City of Portland, Maine – Building or Use Permit Application 389 Congress Street, 04101, Tel: (207) 874-8703, FAX: 874-8716

DATE: 15 Sept 97 ADDRESS: 83-85 Revere St
REASON FOR PERMIT: TO CONSTRUCT (retaining wall) 4'
BUILDING OWNER: Jose Leonard
CONTRACTOR: Stone-Huge Contracting
PERMIT APPLICANT: Jeff Stone APPROVAL: [Signature] ~~DENIED~~
USE GROUP U BOCA 1996 CONSTRUCTION TYPE _____

RETAINING WALL

**CITY OF PORTLAND, MAINE
DEVELOPMENT REVIEW APPLICATION
PLANNING DEPARTMENT PROCESSING FORM**

EXISTING
AND BACKFILL
RET WALL

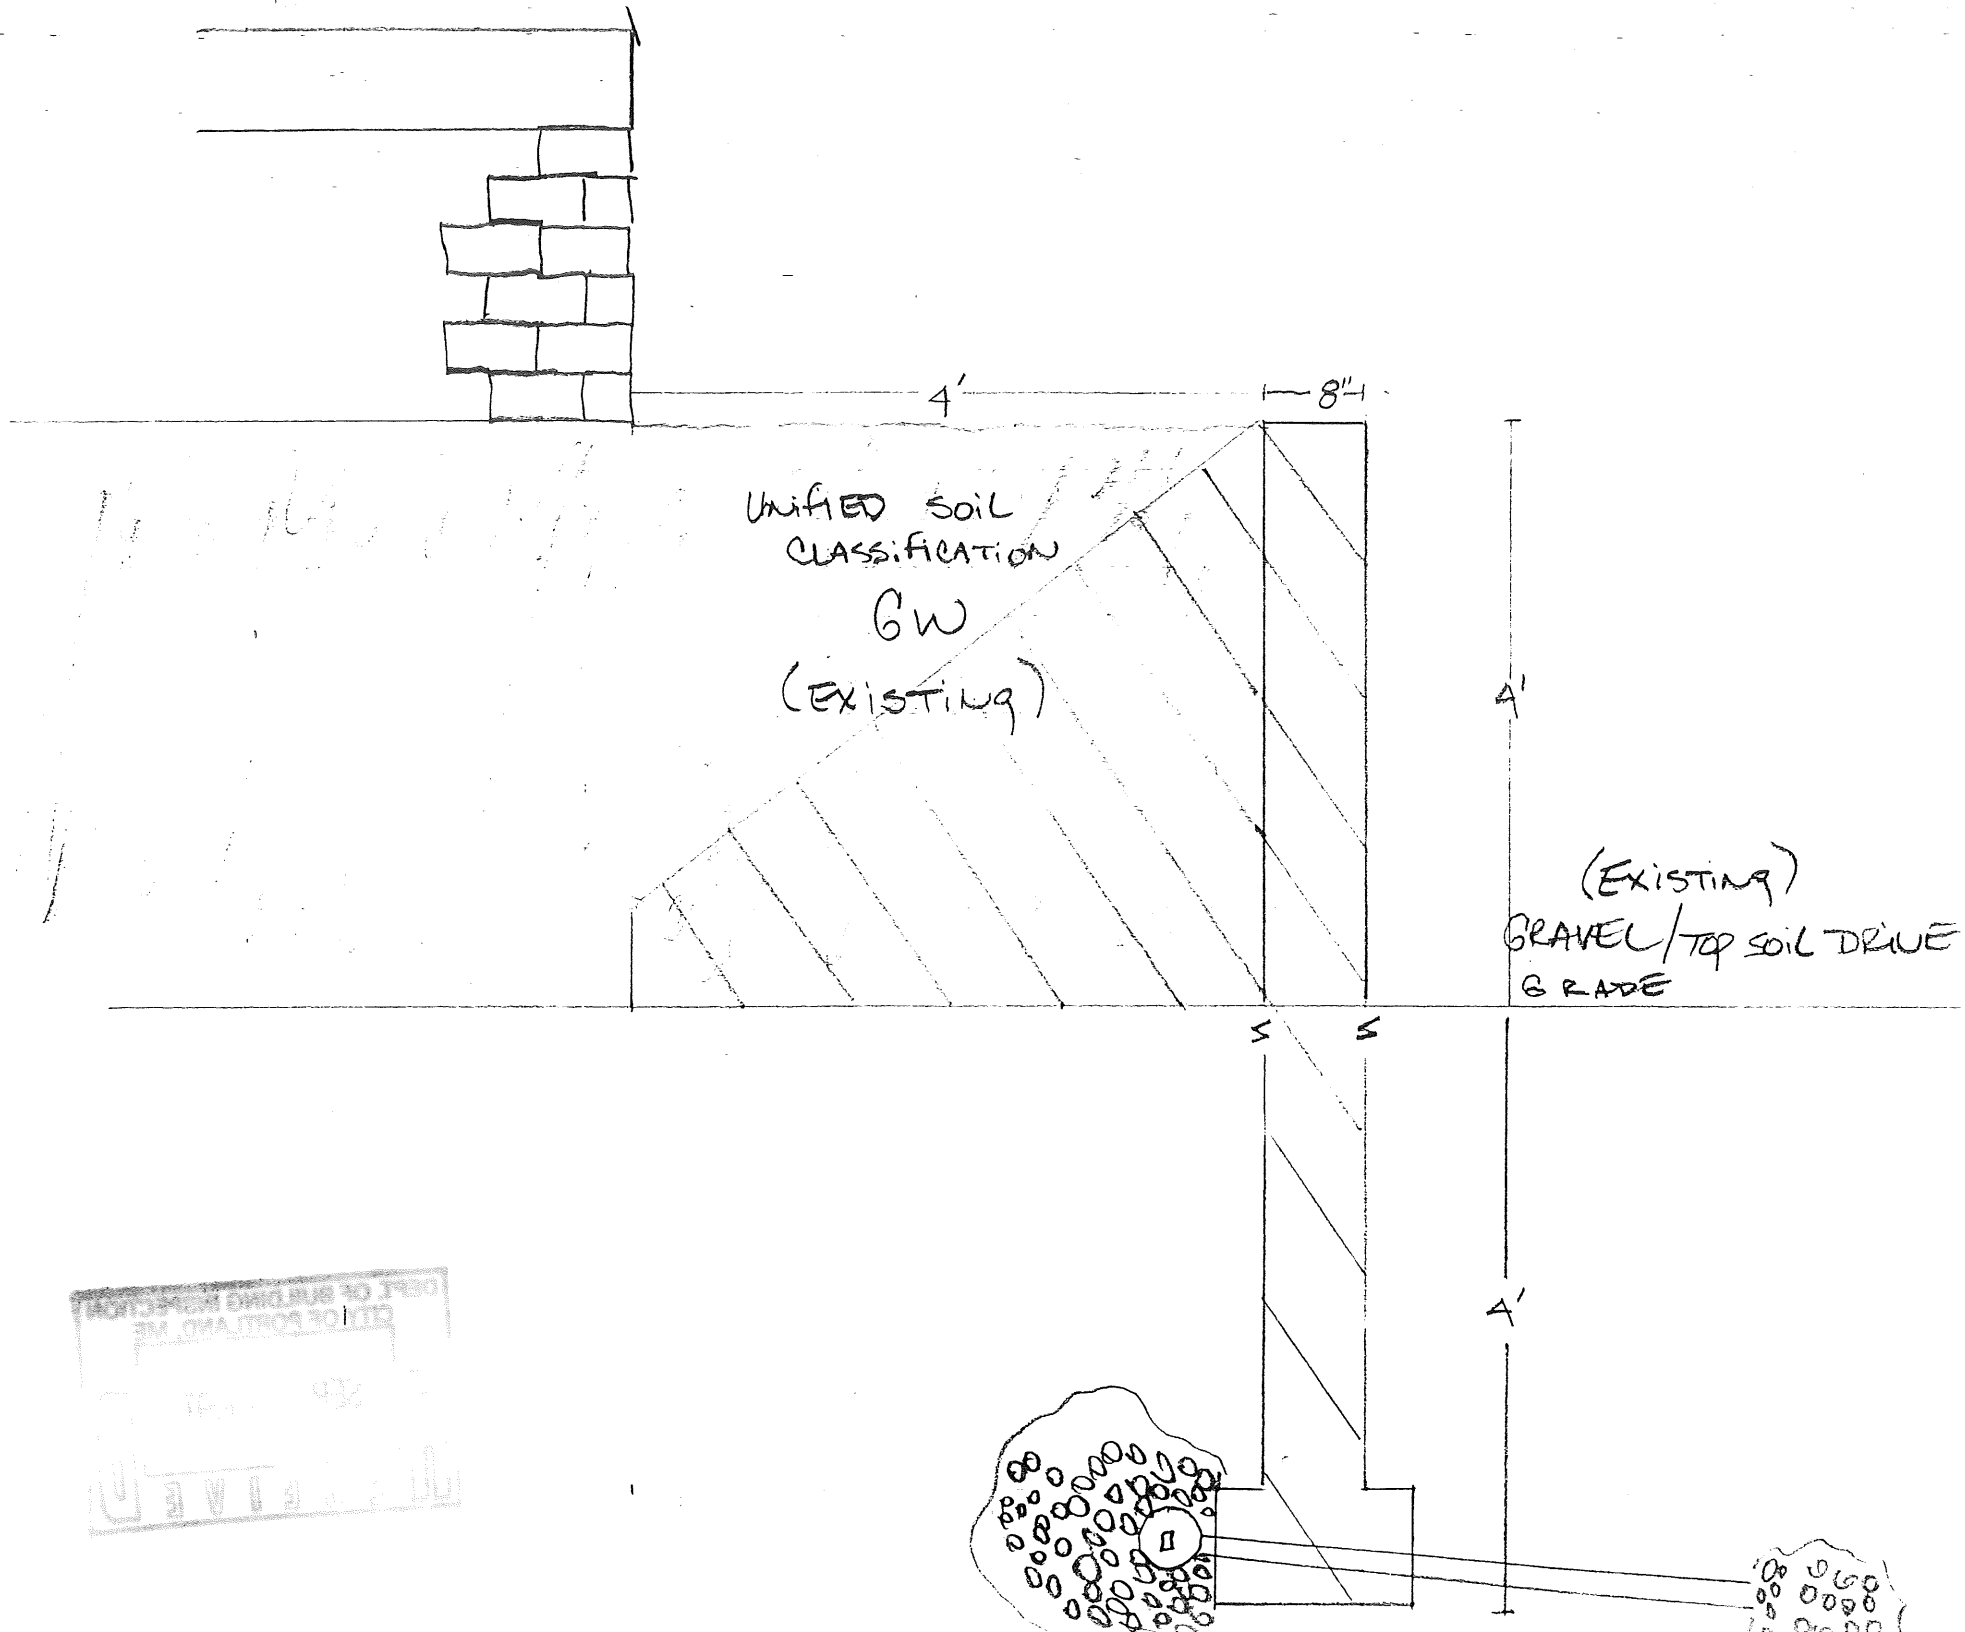
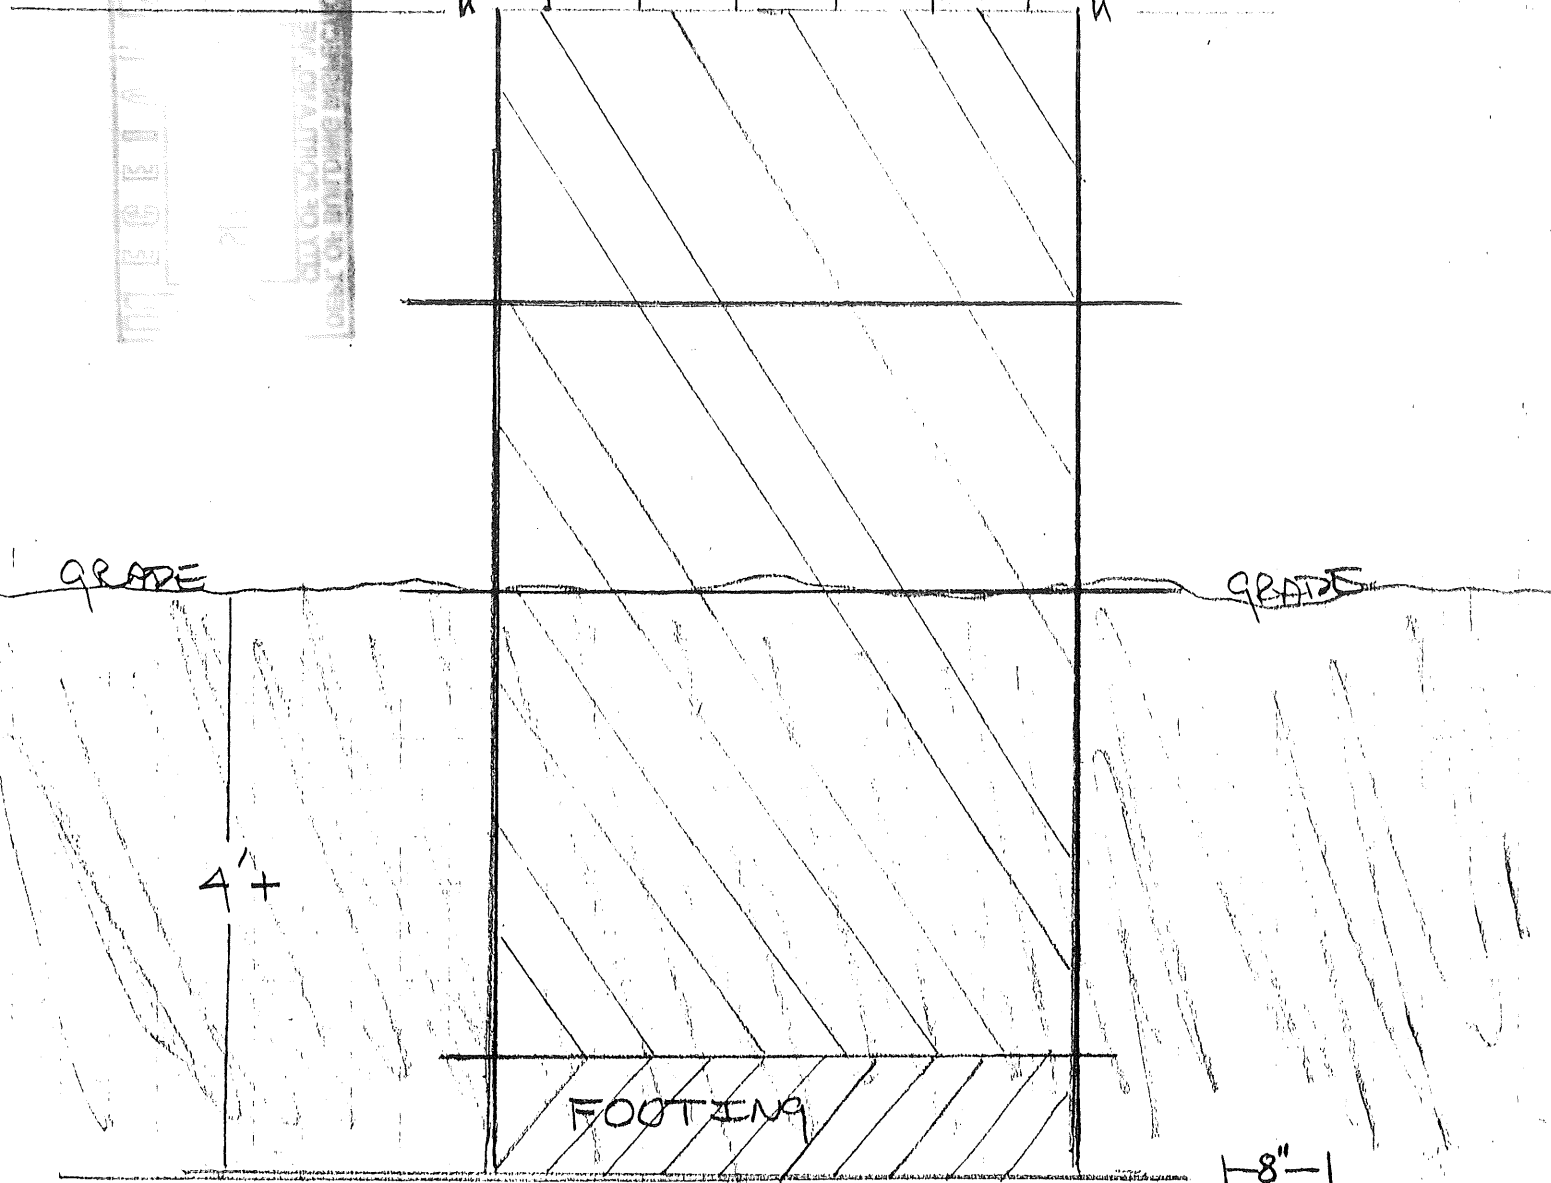
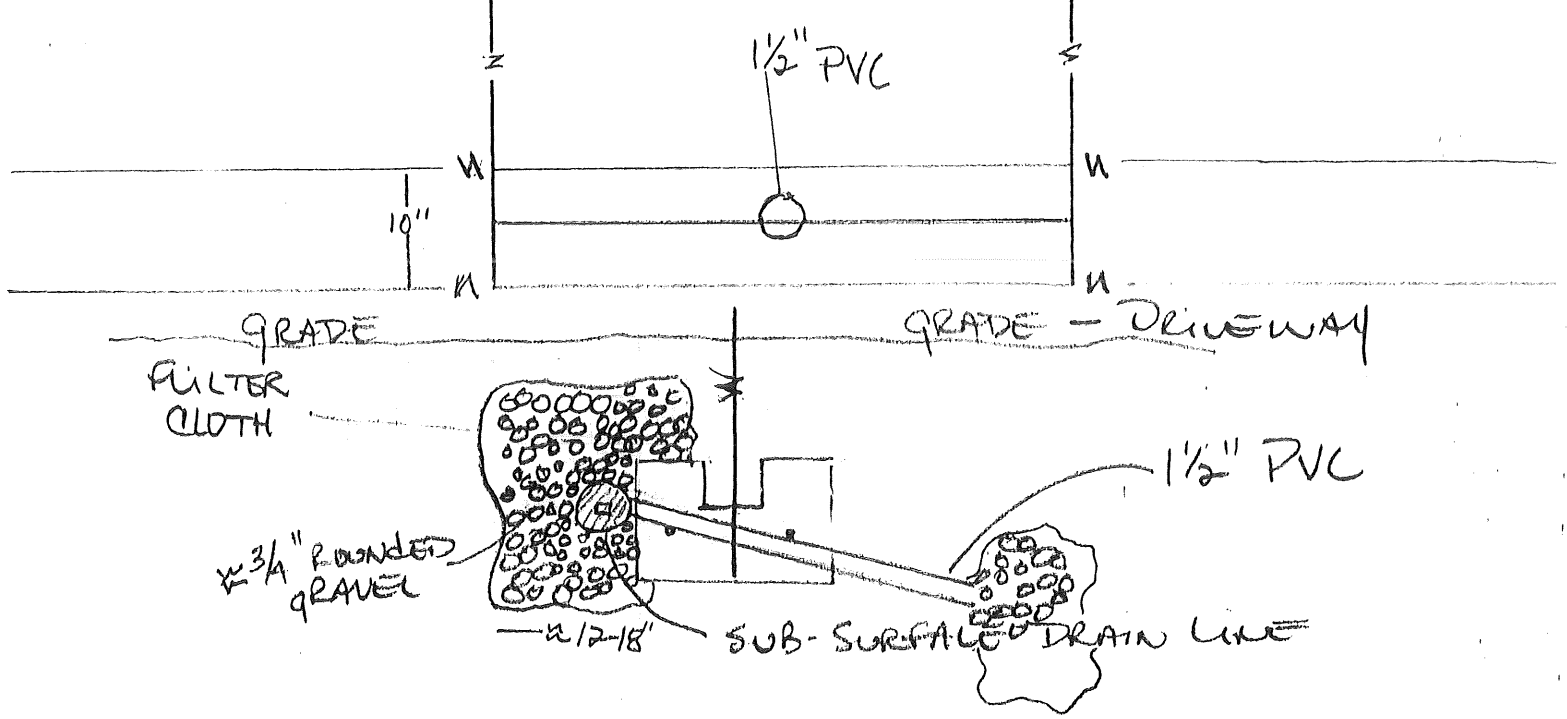
- remove any stockpile of snow before March 1 of each year.
 - a wood guardrail shall be installed from the stockade fence to Revere Street, set in about a foot from the property line.
 - the 4" ditch shall be maintained continuously to ensure drainage flows down the driveway and not onto the abutter's property.
-
